Applicant:	SICK Product & Competence Center Americas, LLC (user) City of Bloomington Port Authority (owner)
Location:	2501, 2601, 2701 American Blvd. E. and 2600 Lindau Lane
Requests:	<ol style="list-style-type: none"><li>1) Rezone 2501 and 2701 American Boulevard E. and 2600 Lindau Lane from LX Lindau Mixed Use (AR-17) to LX(PD) (AR-17) Lindau Mixed Use (Planned Development) (Airport Runway-17);</li><li>2) Preliminary development plans for a multi-phase technology campus at 2501, 2601, and 2701 American Boulevard East and 2600 Lindau Lane;</li><li>3) Final development plans for Phase I of the technology campus;</li><li>4) Preliminary and final plat to adjust property boundaries;</li><li>5) Platting variance to defer park dedication for future development phases;</li><li>6) Conditional use permit for a multi-phase technology campus.</li></ol>
Existing Land Use and Zoning:	Vacant; LX(AR-17) Lindau Mixed Use(Airport Runway) and LX(PD)(AR-17) Lindau Mixed Use(Planned Development)(Airport Runway)

## PROPOSAL

Case PL202100044

**Figure 2: Pre-Cast Concrete Exterior**

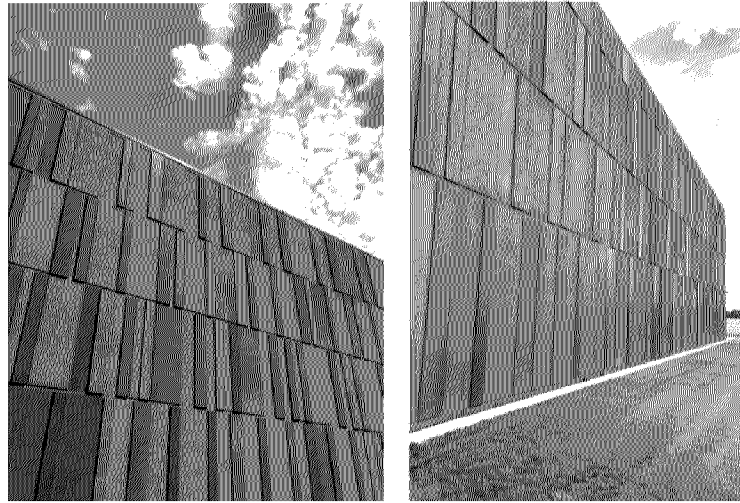
The exterior materials proposed are a mix of glass and pre-cast concrete. Pre-cast concrete, while permitted within industrial zoning districts, requires a deviation from City Code for the LX district. The intent of the limitation is to ensure that an overtly industrial building design is not constructed within a commercial or mixed-use site. The SICK building attempts to balance durability and practicality of a rectangular pre-cast concrete building and the City’s exterior material and structure design requirements. Within the production and warehouse areas, the building design incorporates a significant amount of glass. While the 2 foot to 10 foot transparency requirement would not be met

for the 28<sup>th</sup> Avenue building façade, the Code requirement only applies to 2 and 10 feet above grade. The proposed building elevation includes a similar level of transparency above 10 feet. Although a slight transparency deviation is required for Phase I, the multi-story office buildings proposed for Phases II and IV are comprised almost entirely of glass. The glass facades, along with future public plazas along Lindau Lane and 28<sup>th</sup> Avenue S., will create an interesting and high-quality pedestrian environment.
